12/10/25 CITY SUBMITTAL

**STORM SEWER
PLAN**

C4-2

CIVIL DETAILS

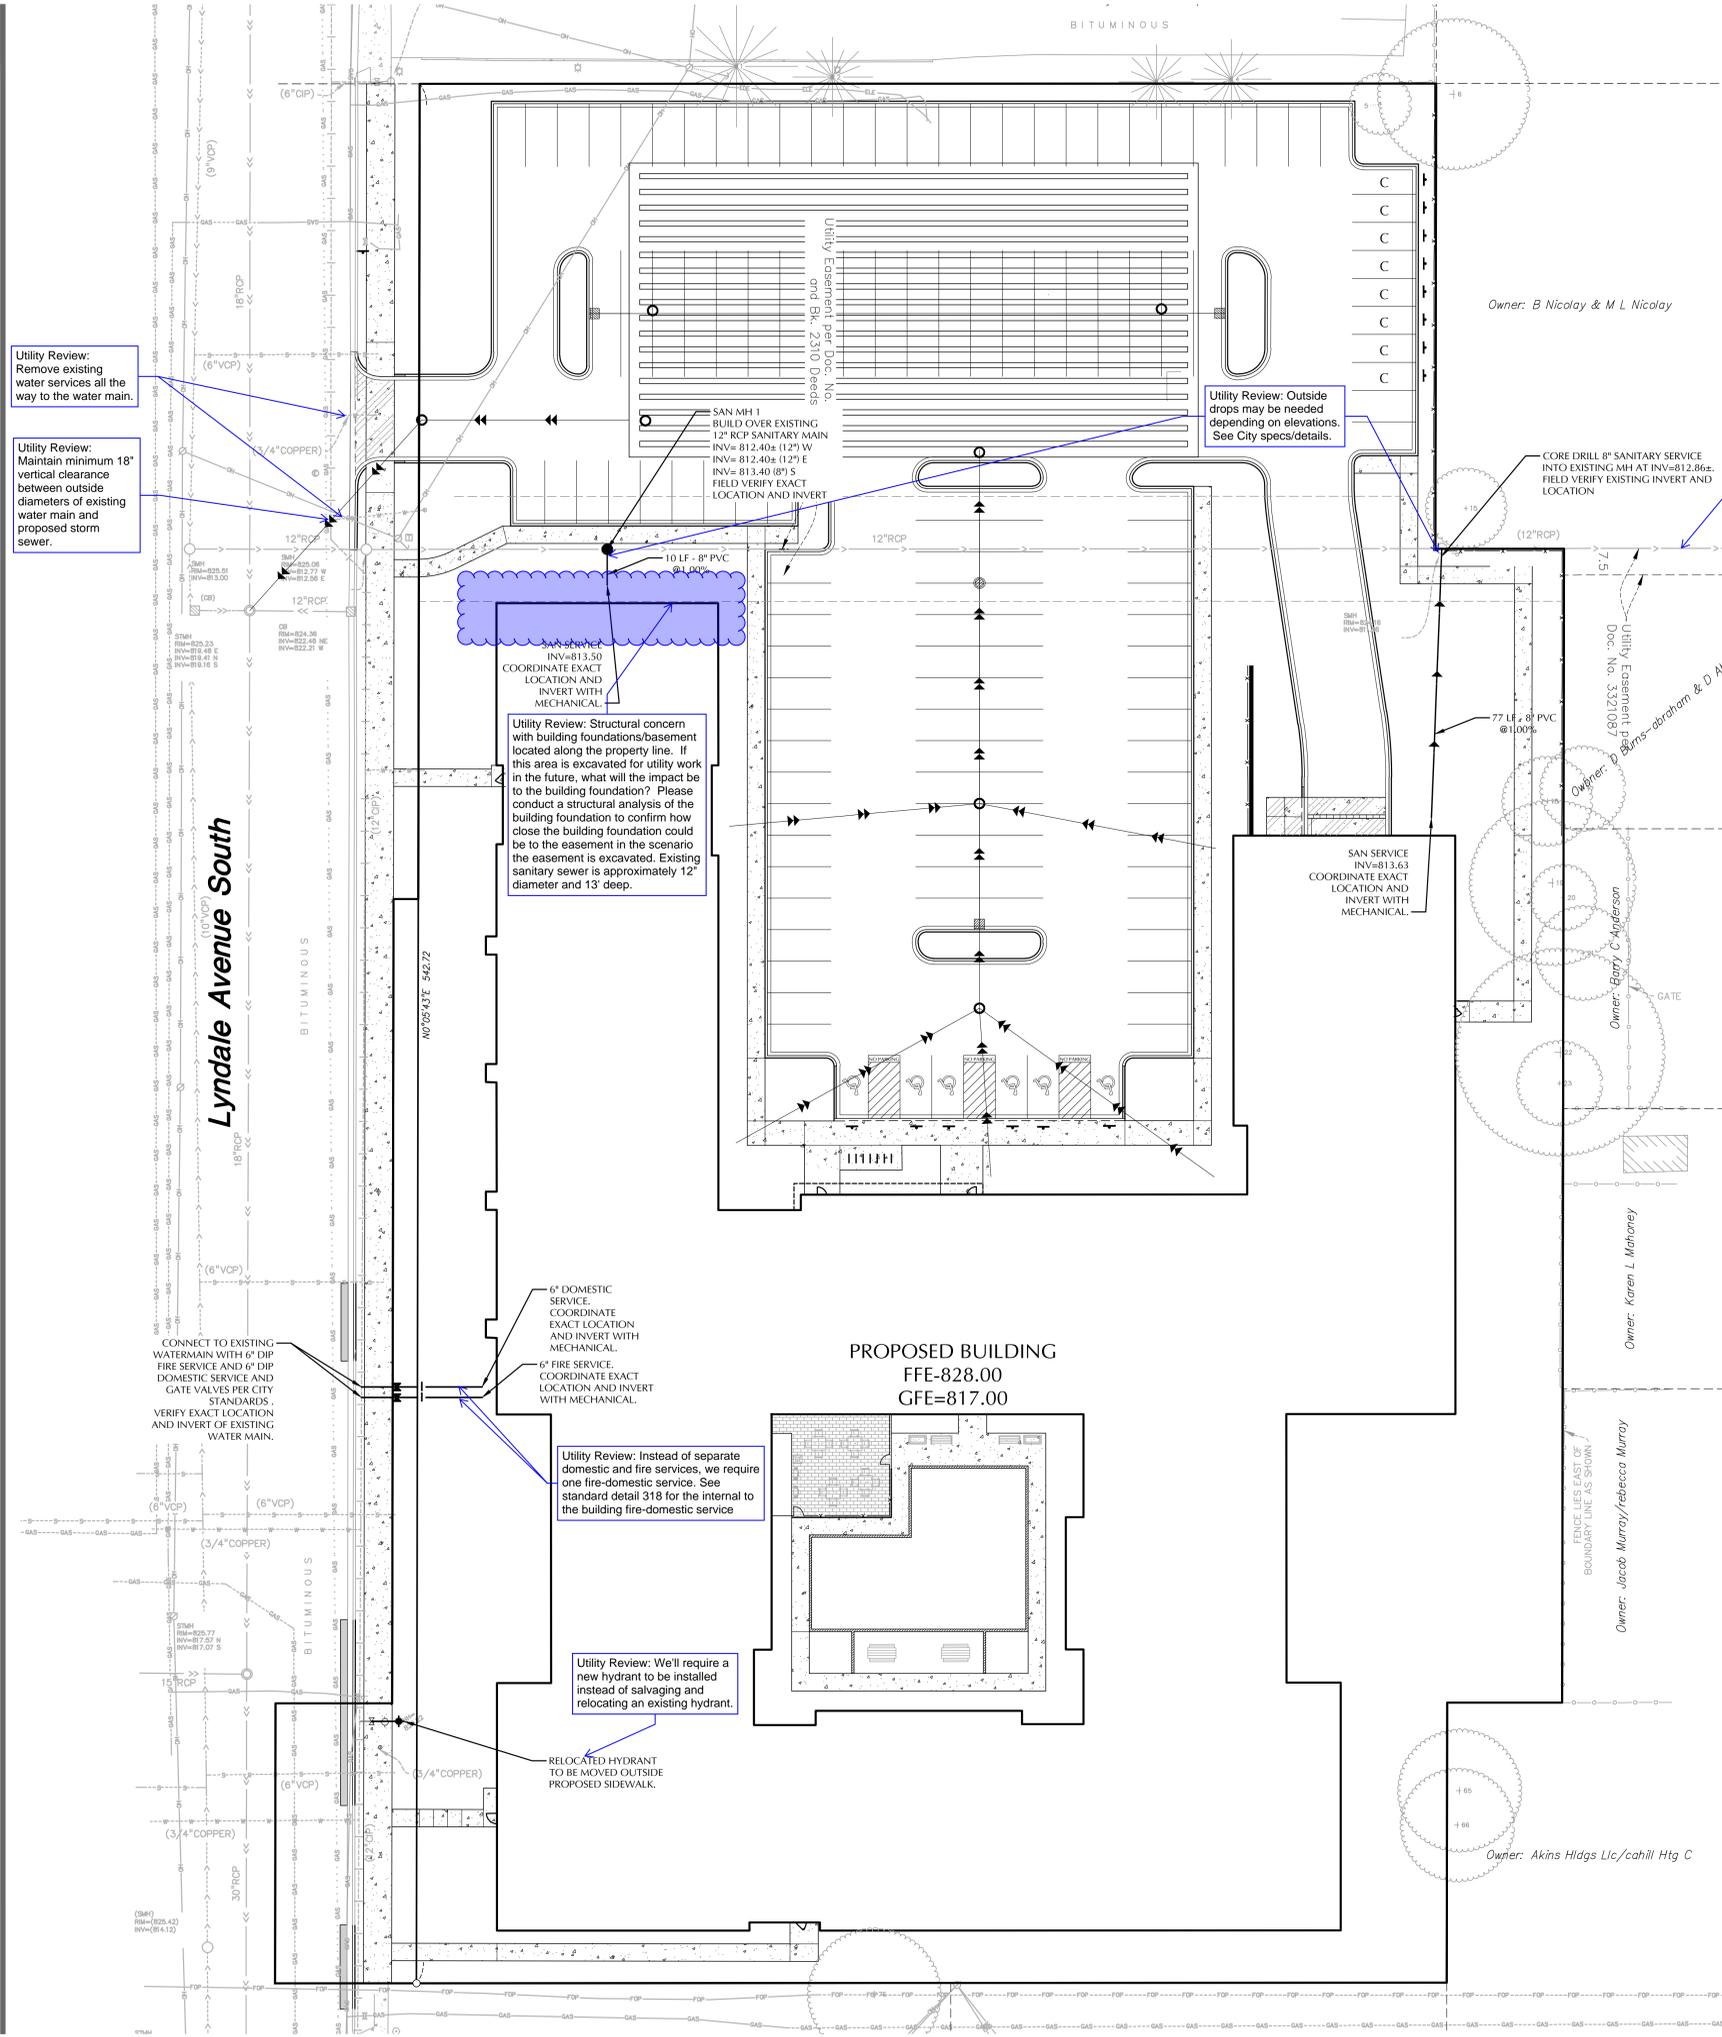
Utility Review: Maintain minimum 18" vertical clearance between outside diameters of existing water main and proposed storm sewer.

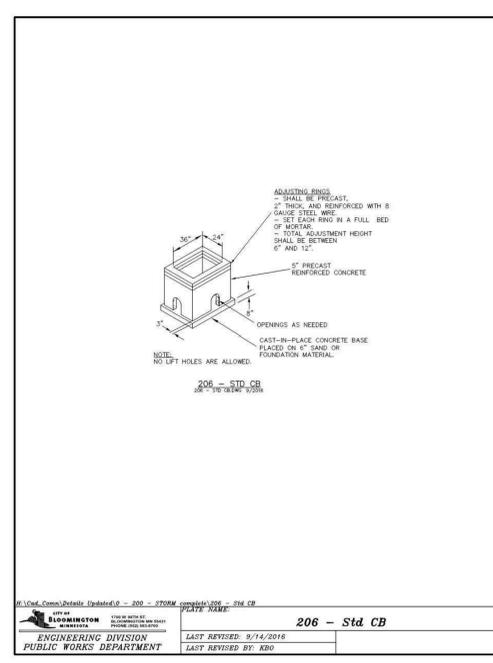
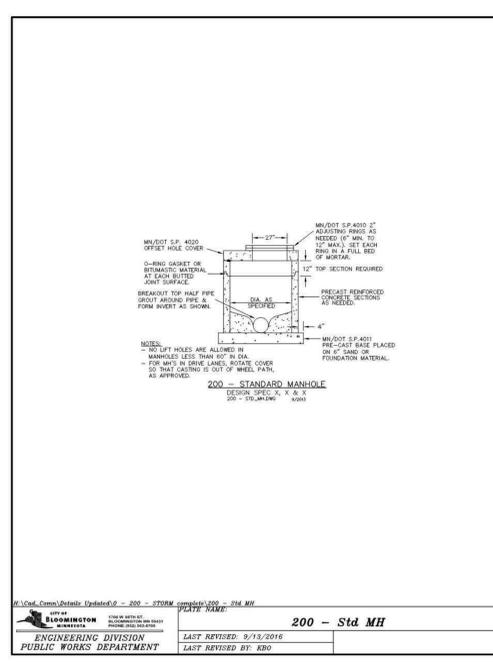
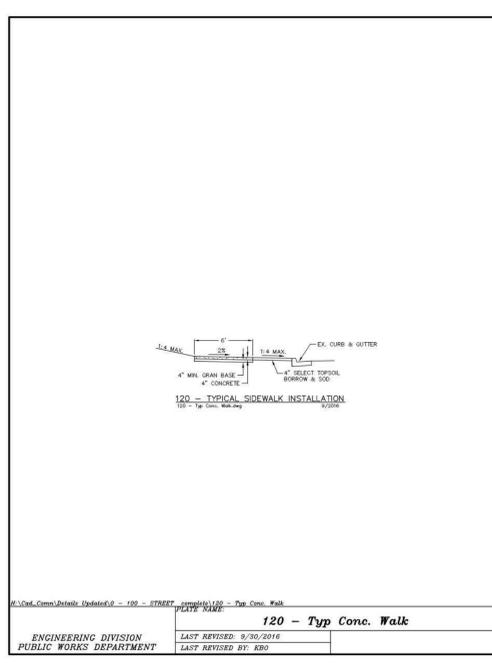
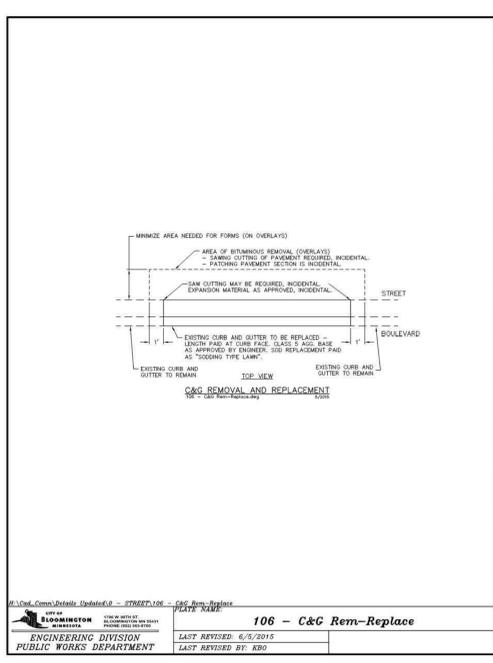
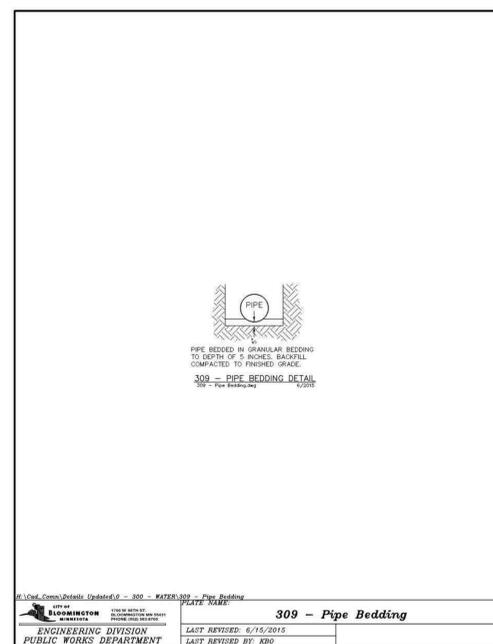
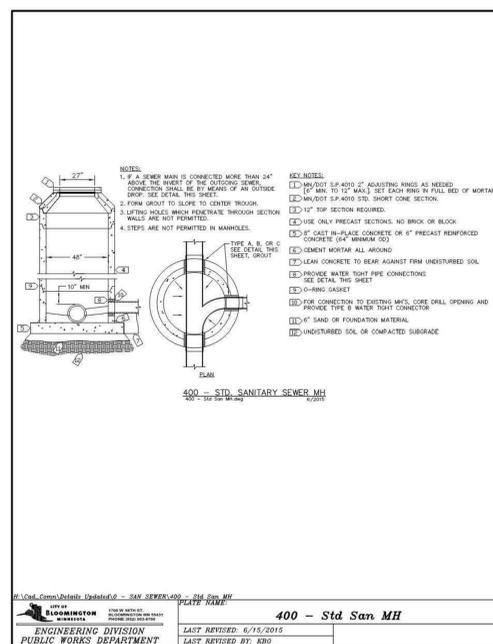
Utility Review: Depending on elevations of proposed sanitary services connecting to public sanitary sewer, may need to add detail for outside drops.

Utility Review: Add detail for fire-domestic service.
